Consultation Response from ECC Urban Design and Landscape Officer:

Project/Application - Repair Garage & 81 Victoria Street, St James's

Application ref: 23/0949/FUL

1 North Block_North-East Elevation
1:100

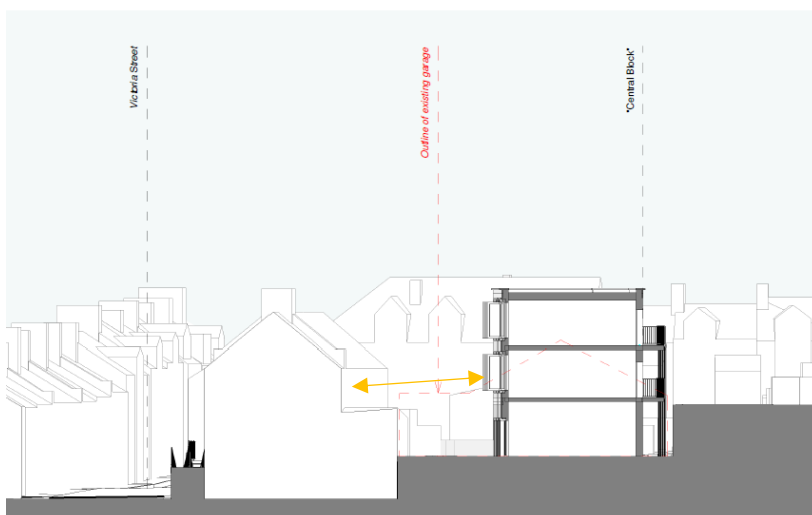
- 2.1.2 Existing houses to Prospect Park are located directly to the north – there will be an overbearing presence to their rear gardens. The proposed massing along this edge of the site rises from 2 to 4 storeys (with a further storey below ground level) and the walls are without any fenestration (see elevation below). The existing trees that currently line this boundary are to be removed (although some design drawings / text suggest that they might be retained, this loss is inevitable - as confirmed by the tree removal drawing in the arboricultural report) and so the proposed development will appear to be extremely oppressive as an outlook from both the existing dwellings and their gardens and the orientation means that the impacts on the availability of sunlight to the gardens will be substantial and permanent. This has been evidenced in the Sunlight + Daylight Report which indicates that several gardens fail compared to the BRE guidelines.

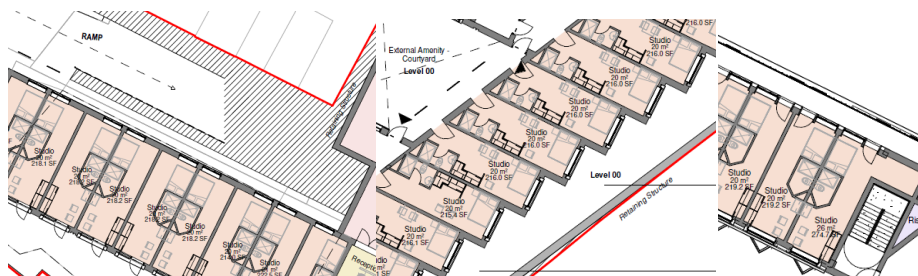
- 2.6.1 General access for maintenance, etc to the semi-private 'gap' spaces behind the railway embankment retaining wall (far right, site section 06) and the space to the north of 77-80 Victoria Street is not clearly defined and may rely on a route being negotiated through one of the private studio units?

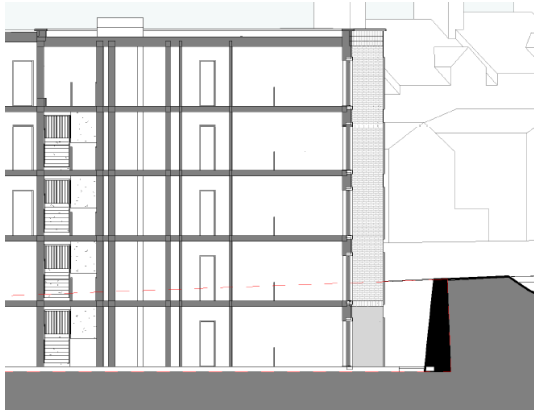
- 2.6.4 Semi-Private (shared) Roof Terraces are illustrated in the DAS and these are a welcome idea (but the Second Floor Plan shows them as roofs?). The detailed layouts as illustrated do not promote sociable patterns of use and, located at second floor level then, they do not link to any other internal spaces that might relate and help to animate their role (such as a communal dining space or lounge, for instance).

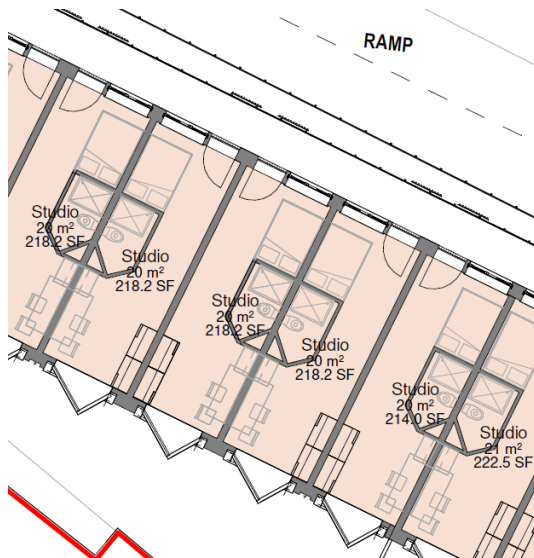
- 2.8.2 Due to the proximity of the northeast wall of the development to the site boundary, corridors providing access to studios in the northern block are without 'views out', nor do they have natural light and ventilation:
